PROJECT NUMBER: SP2024-037
PROJECT NAME: Amended Site Plan for 5901 Horizon Road
SITE ADDRESS/LOCATIONS: 5901 HORIZON RD

SUBJECT: SP2024-037; *Administrative Site Plan for Garages of America*

GARAGES OF AMERICA
5901 HORIZON ROAD
ROCKWALL, TEXAS 75032

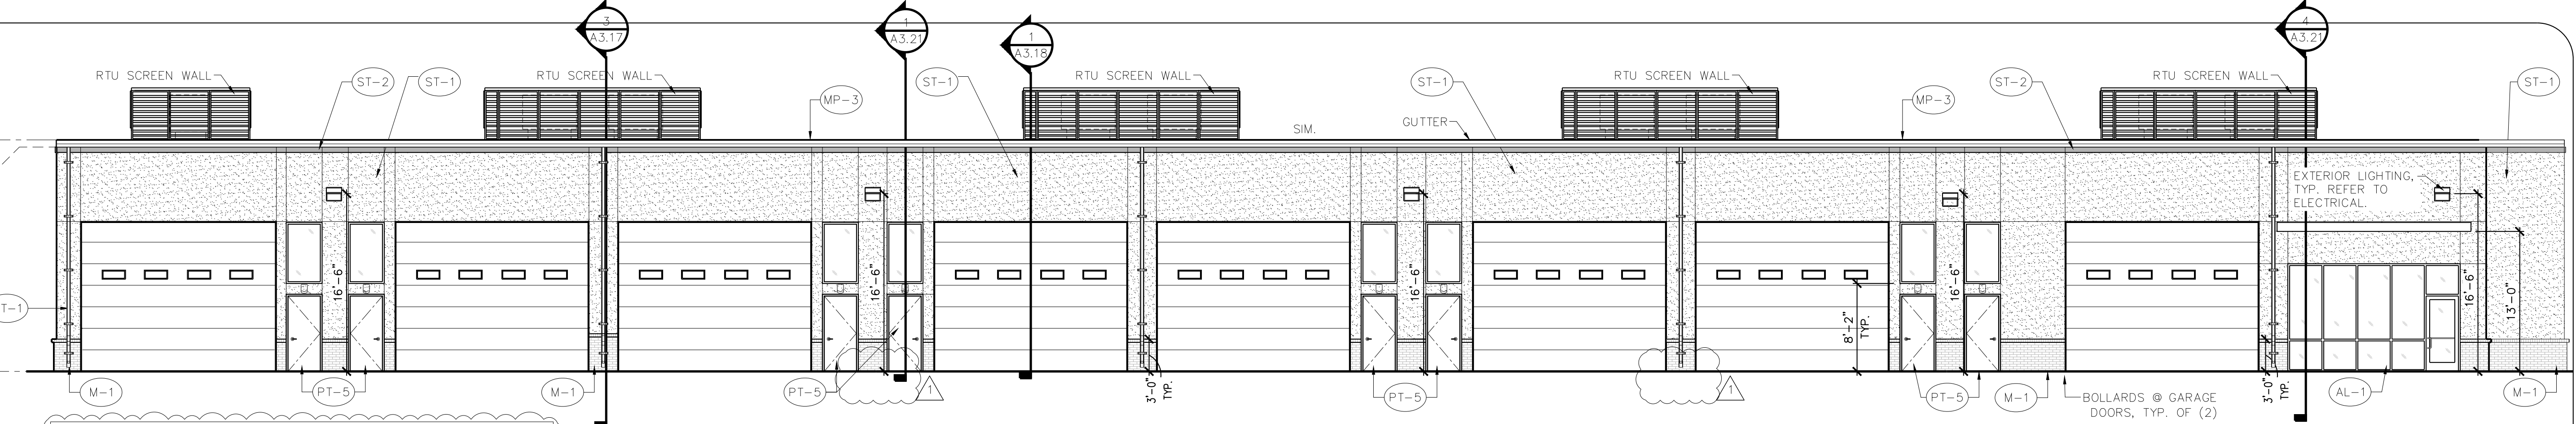
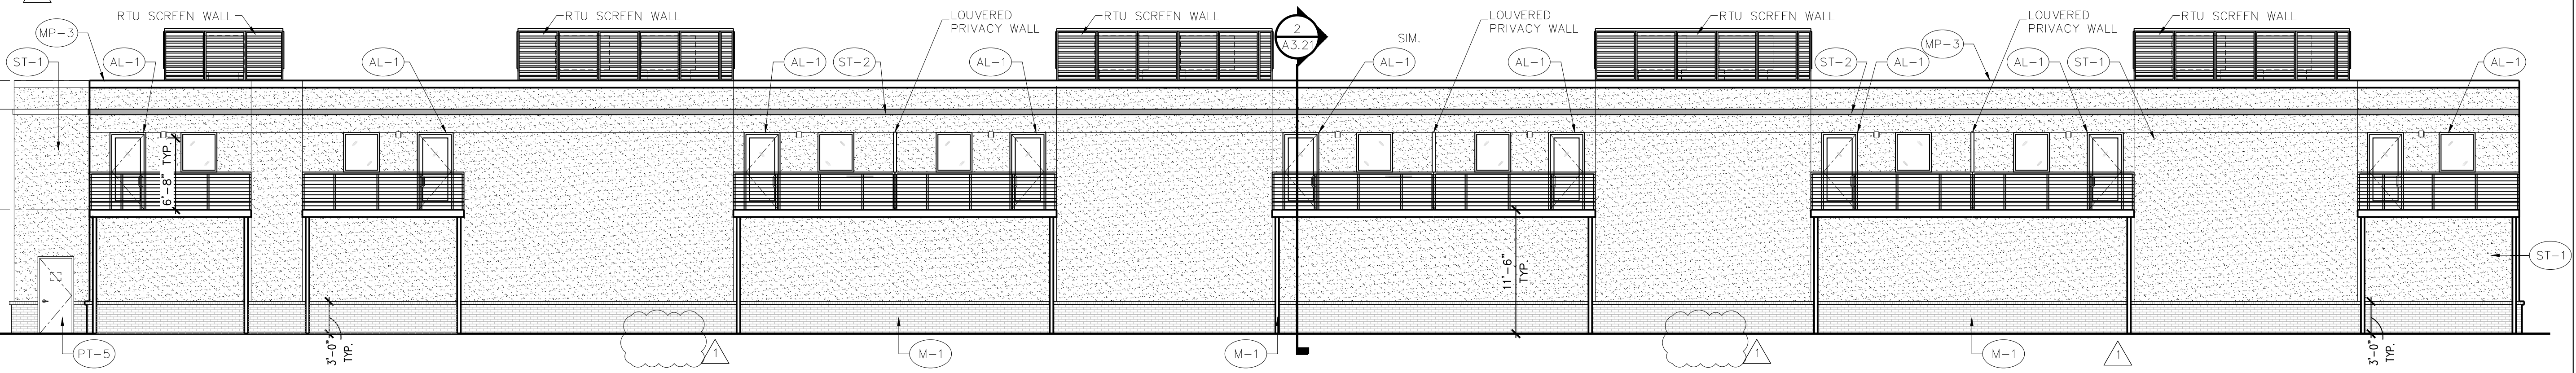
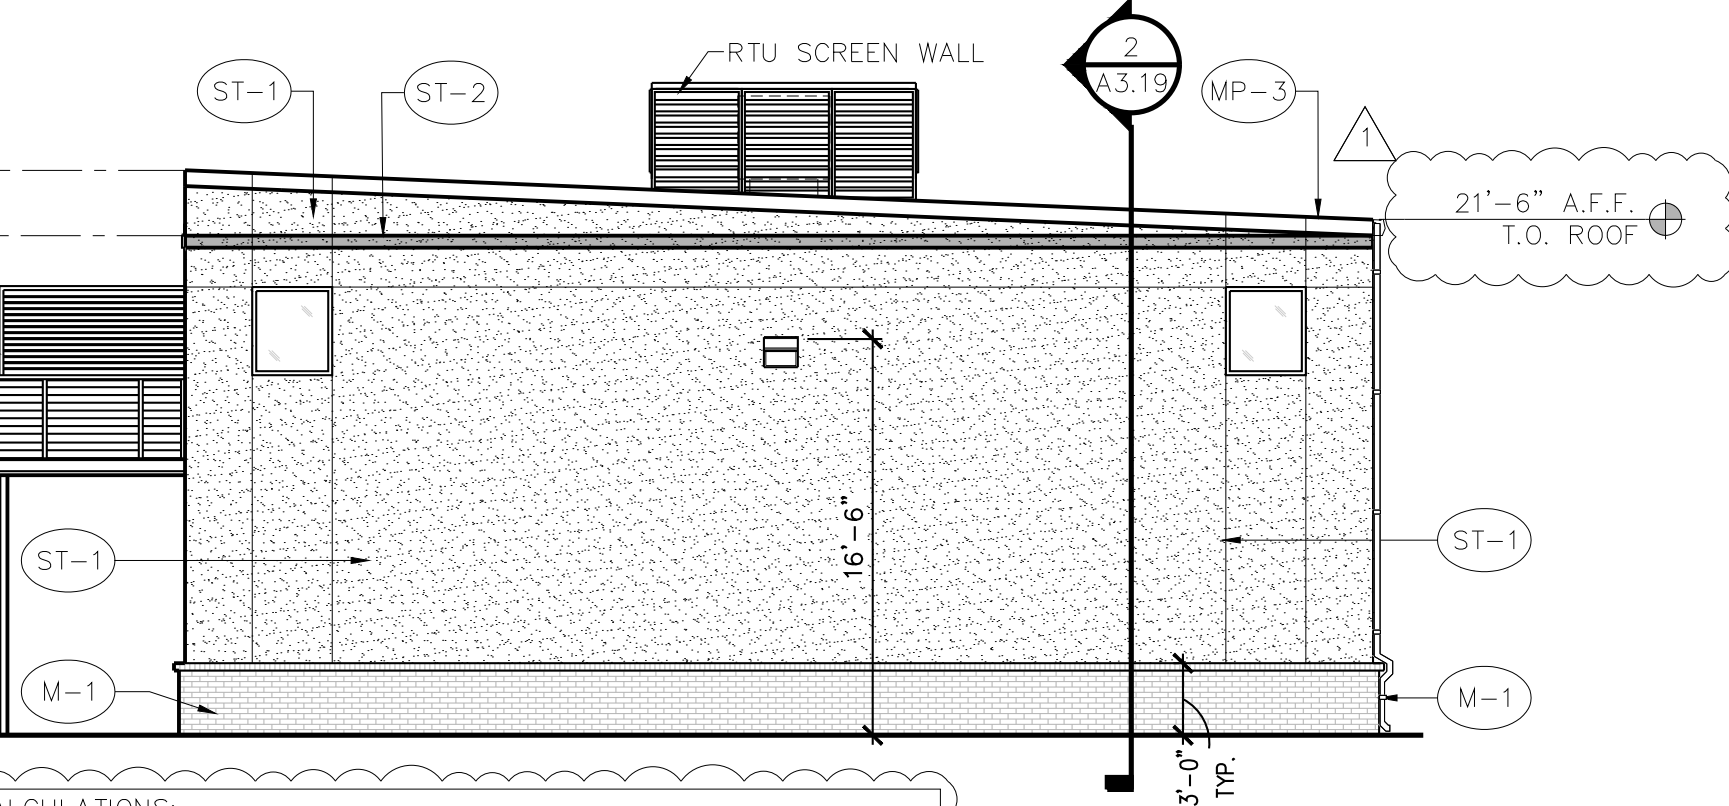
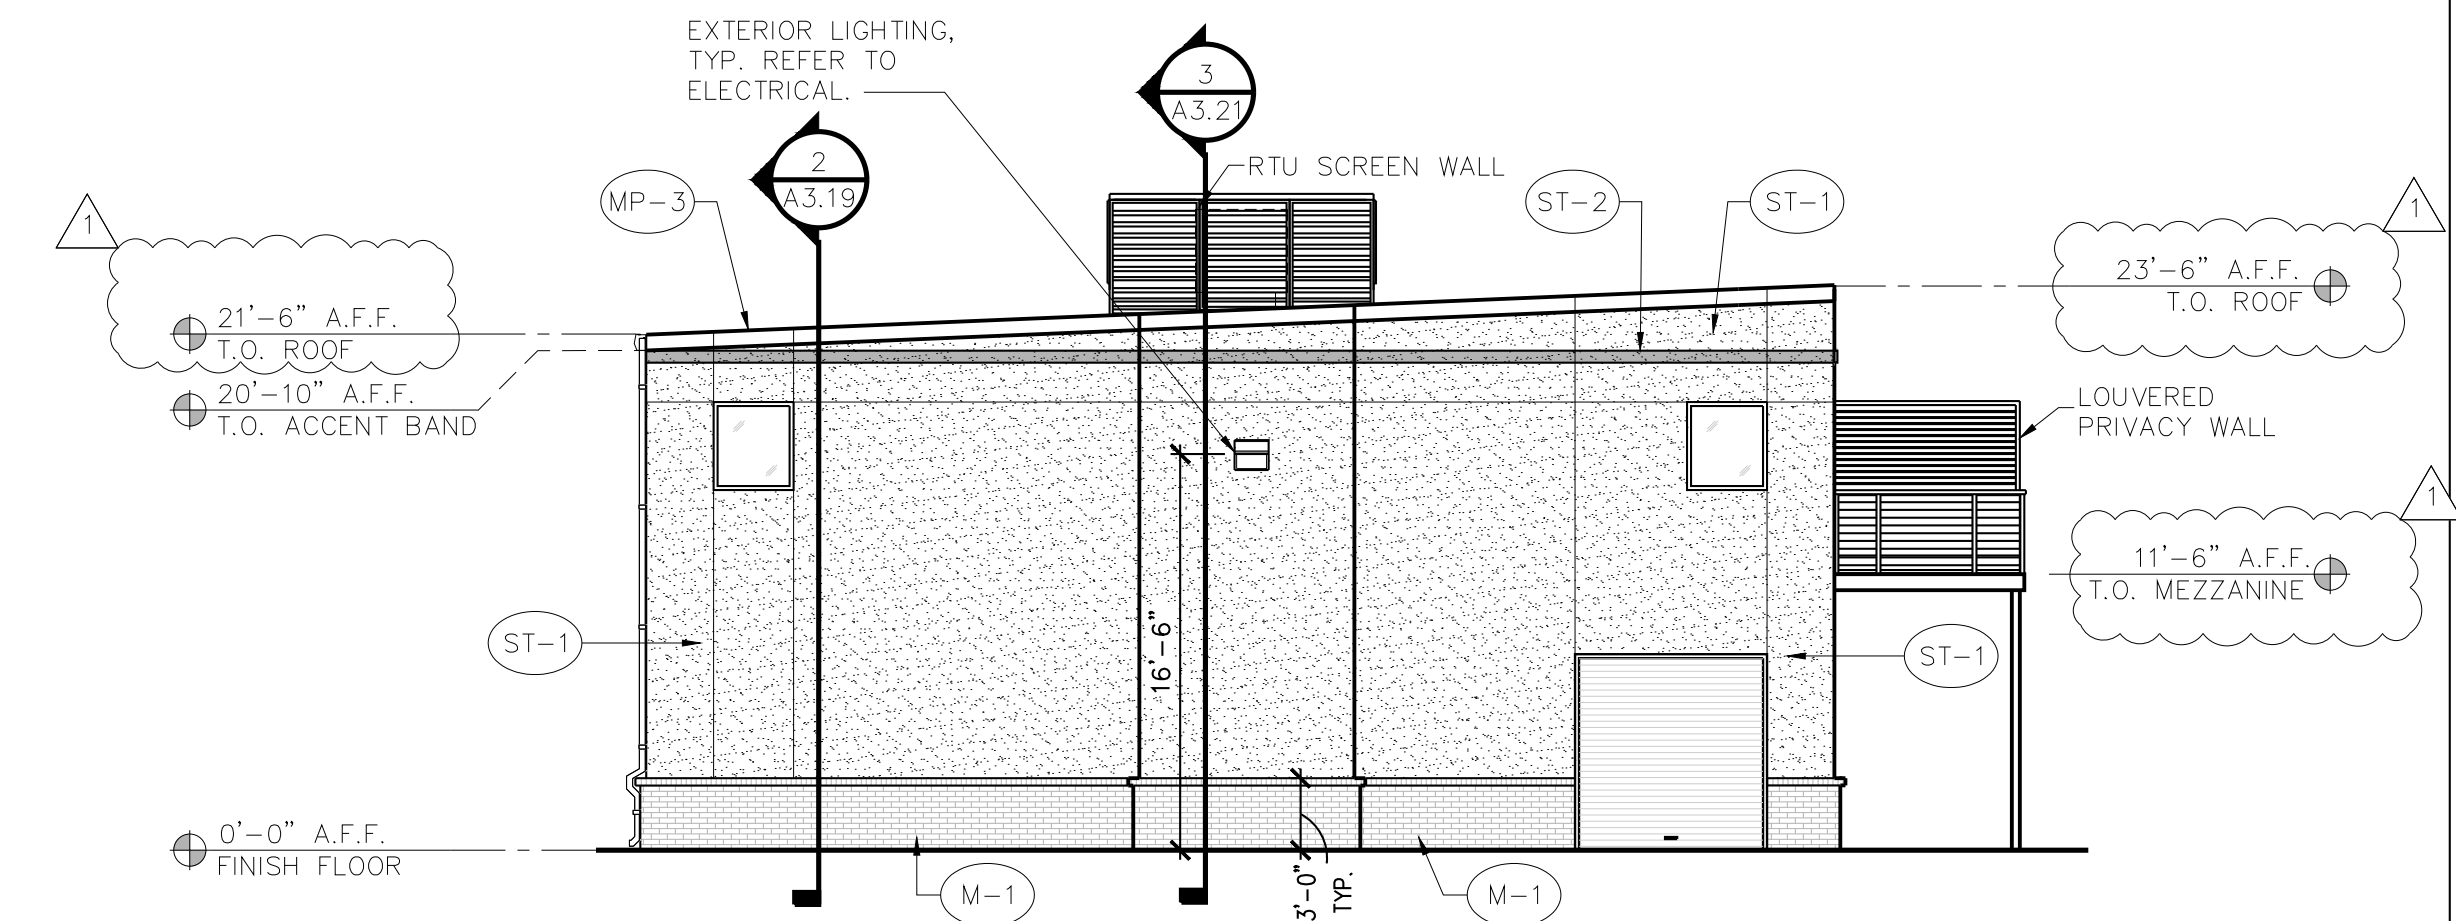
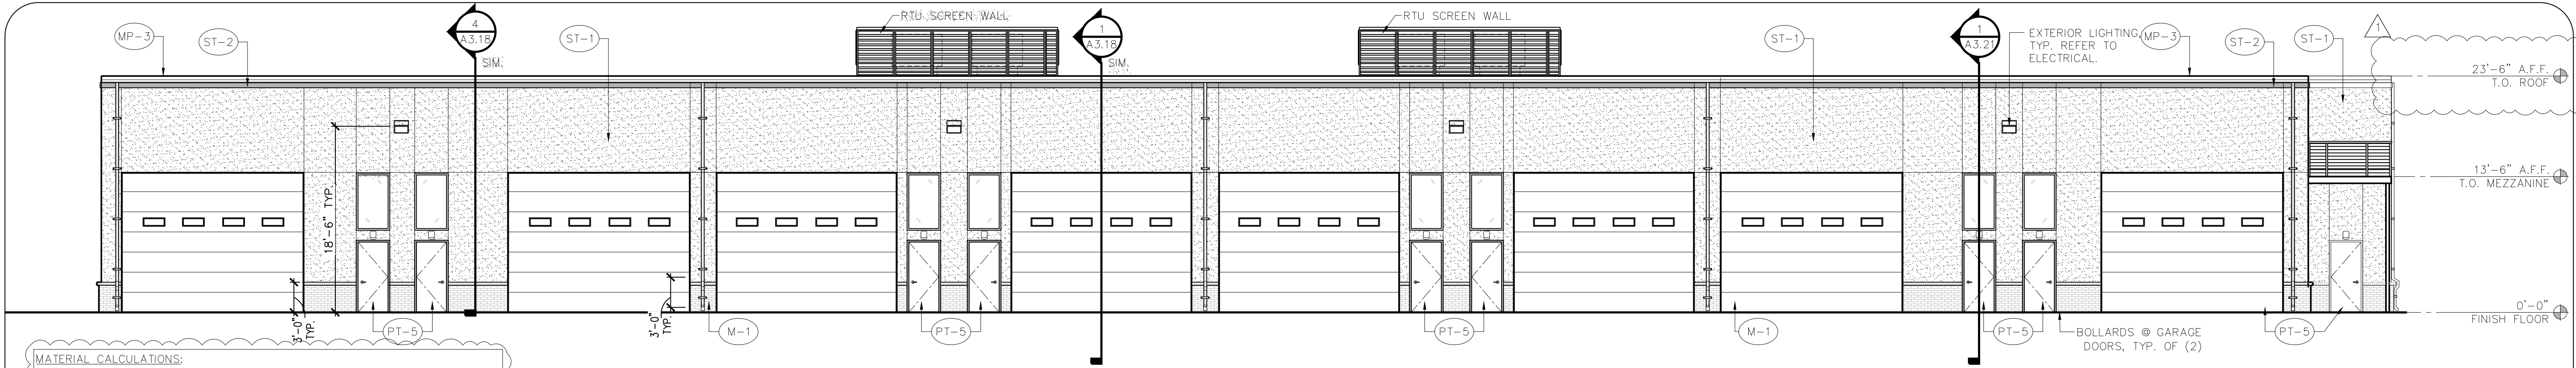
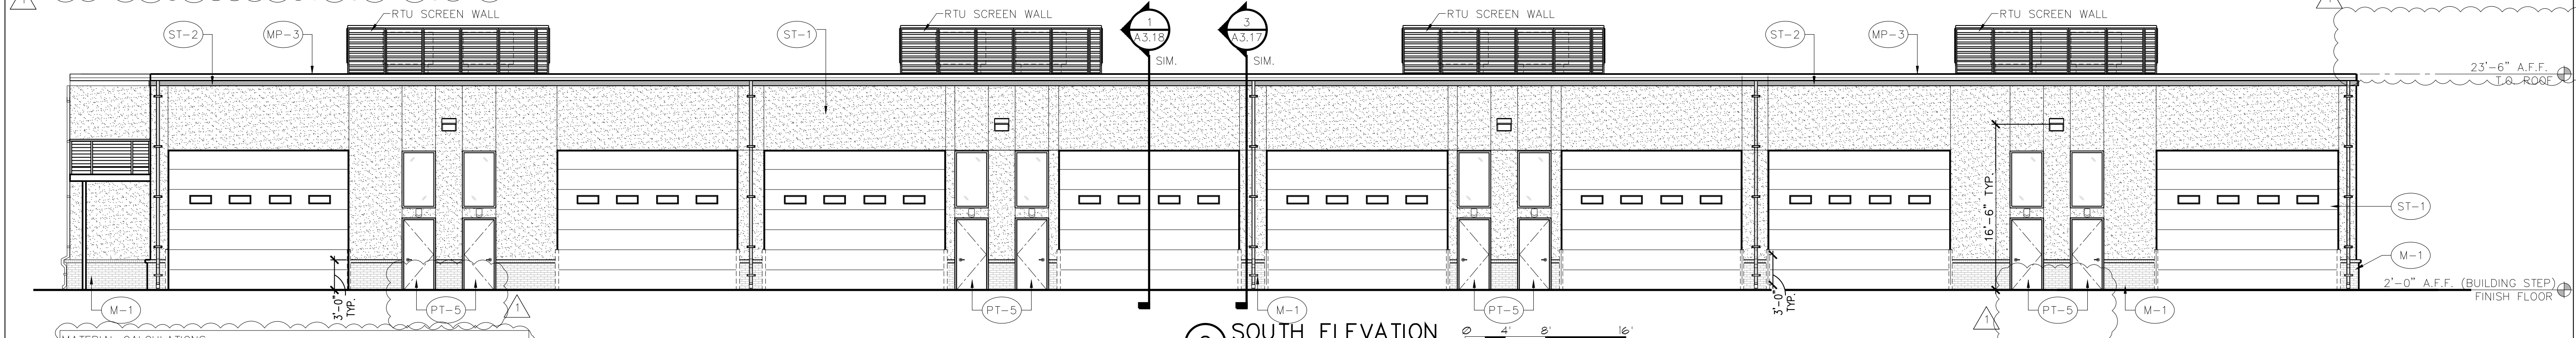
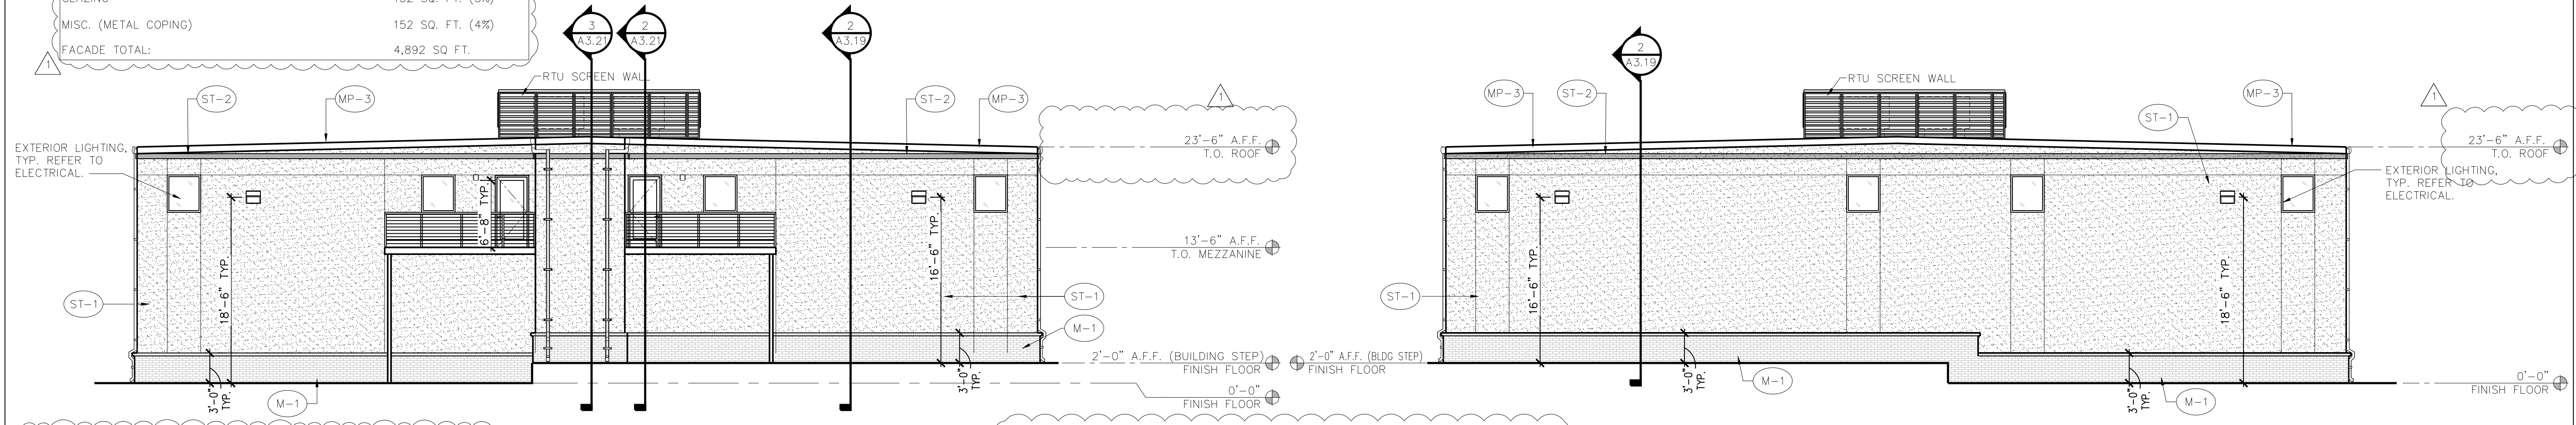
- (1) Please provide Building 1 with the Phase 1 building elevations; Building B was included twice. (Subsection 06.02, of Article 05)
- (2) Please remove the doors and windows from the material percentages. Staff needs to verify that the material requirements are still met. (Subsection 04.01, of Article 05)
- (3) Please indicate the roofing material on the pitched roof buildings. If metal, they must be standing seam; include this on the material table for each building. (Subsection 04.01, of Article 05)
